Charlton Brown Architects

Ridgefield, Courtenay Avenue, London N6 4LP.

G.A. Elevation, Side (North) 1186 / WD 202

Side (North) Elevation

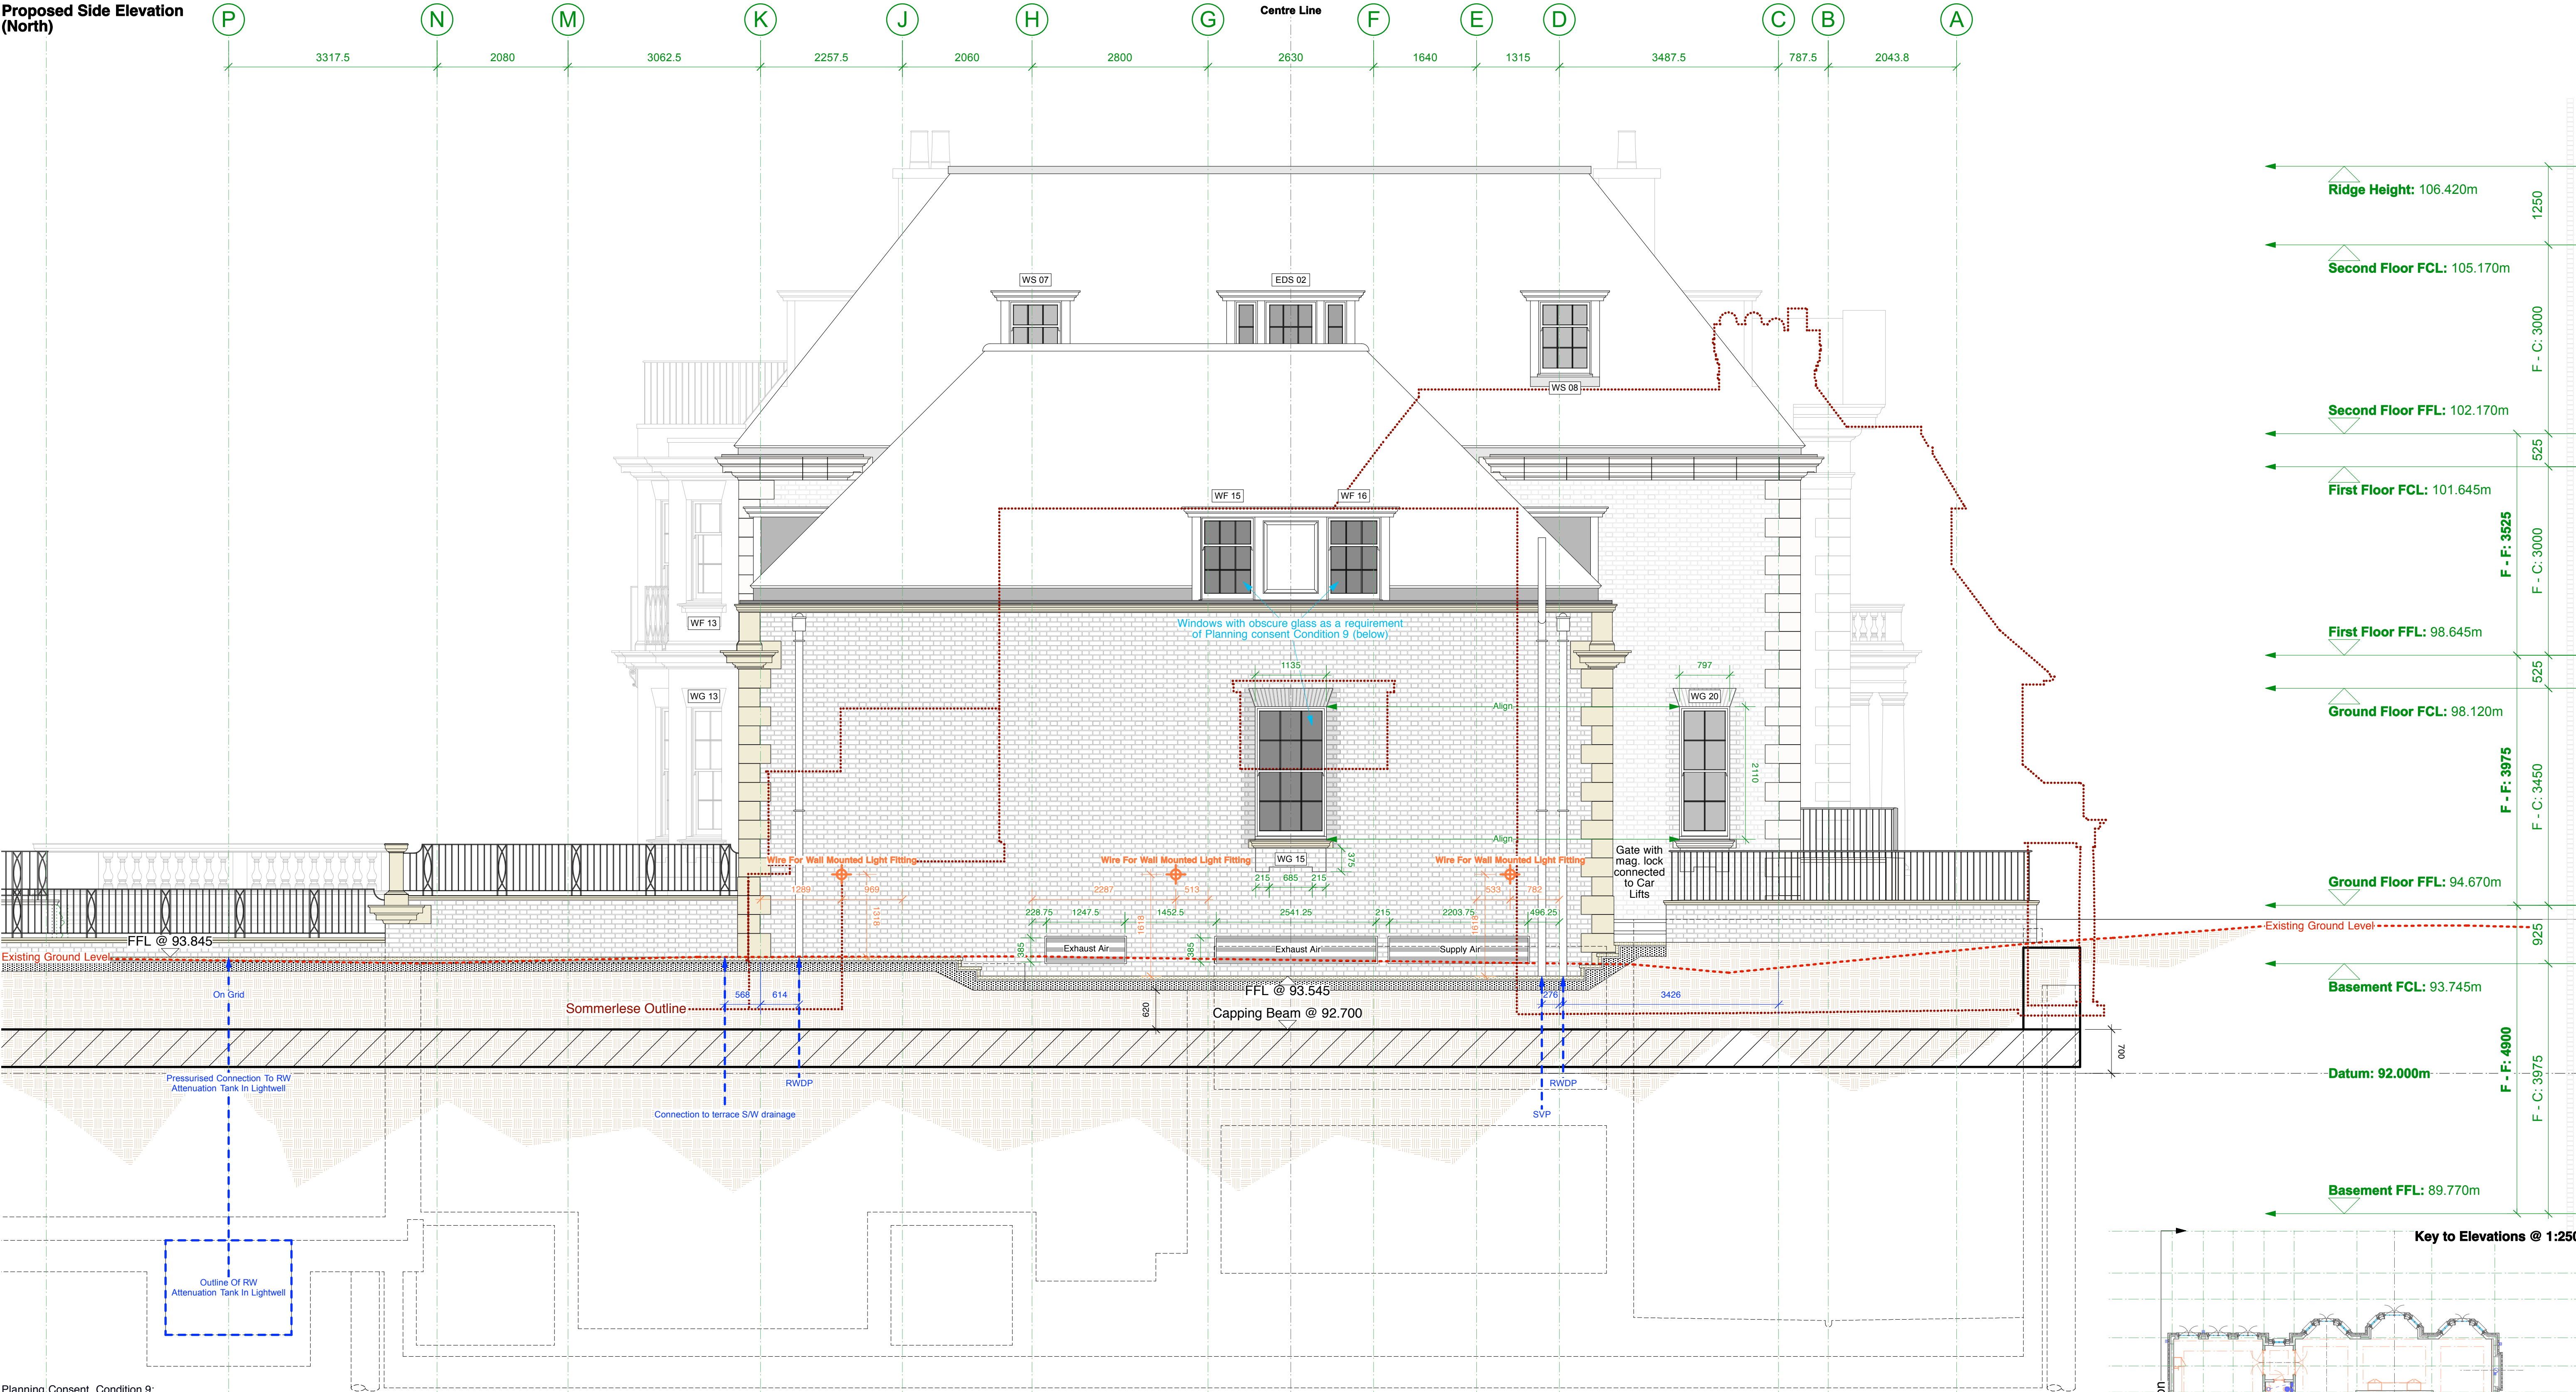
Tender Issue - Window dimensions added. See notes in **PURPLE**. Drawing issued for costing. 18/05/15 CT **T4**

Tender Issue - See notes in **BLUE**. Drawing issued for costing. 26/06/15 CT **T5**

Tender Issue - Setting out of external electrical items shown in **ORANGE**. Drawing issued for costing. 27/11/15 CT **T6**

Setting out of external electrical items shown in **ORANGE** updated. 18/03/16 CT **T7**

See notes in **PINK**. 01/04/16 CT **T8**

Railings to sunken garden and rear terrace updated. Drawing issued. 04/01/17 CT **T9**
